AMENDED IN RED

REVISION			DATE	ISSUE DETAILS		DRAWN	DESIGN	DRAWN	STATUS	SCALE		CLIENT	PROJECT		DRAWING TITLE					
1			27.10.21	ISSUED FOR INFORMATION		CH	CH		PRELIMINARY NOT FOR CONSTRUCTION	1:500 10 5 0 10 20m A1					WEINAM CREEK GENERAL			OVERALL LAYOUT PLAN SHEET 2 OF 3		
2			04.11.21	ISSUED FOR INFORMATION		CH	CH			1:1000  A3										
3			03.12.21	ISSUED FOR INFORMATION		CH	CH													
								DESIGN

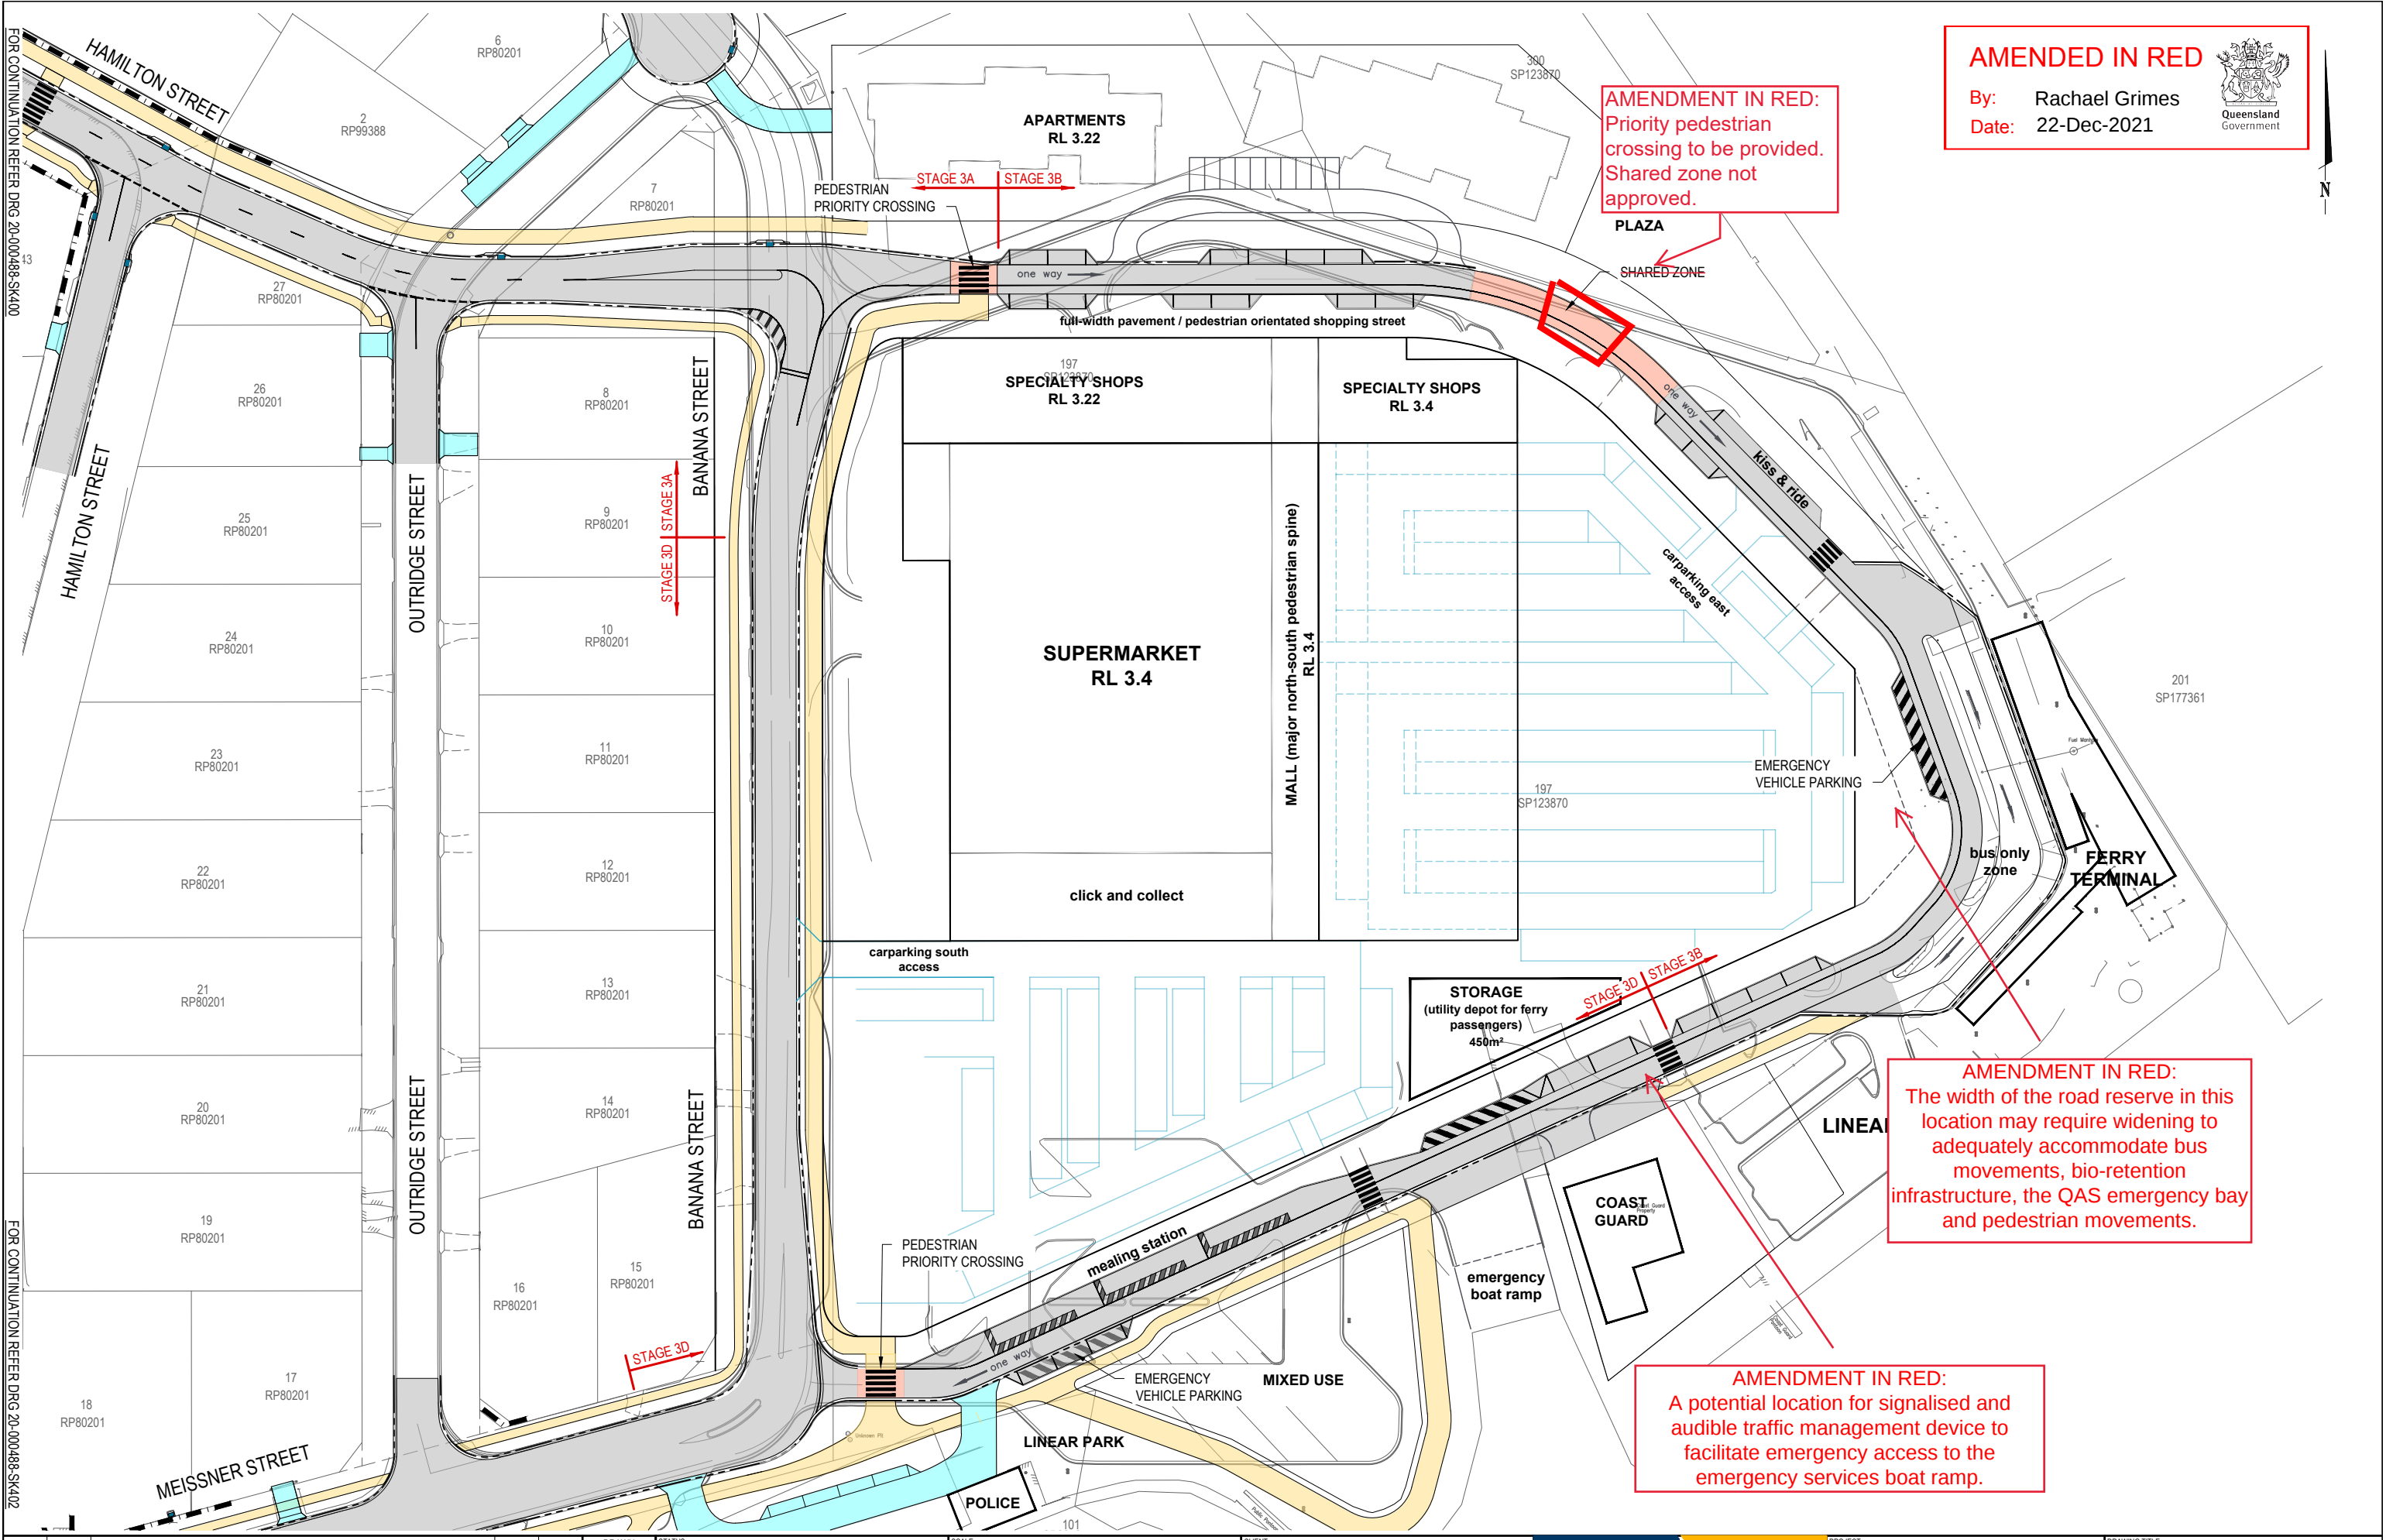
AMENDMENT IN RED:
Priority pedestrian crossing to be provided.
Shared zone not approved.

AMENDMENT IN RED:
The width of the road reserve in this location may require widening to adequately accommodate bus movements, bio-retention infrastructure, the QAS emergency bay and pedestrian movements.

AMENDMENT IN RED:
A potential location for signalised and audible traffic management device to facilitate emergency access to the emergency services boat ramp.
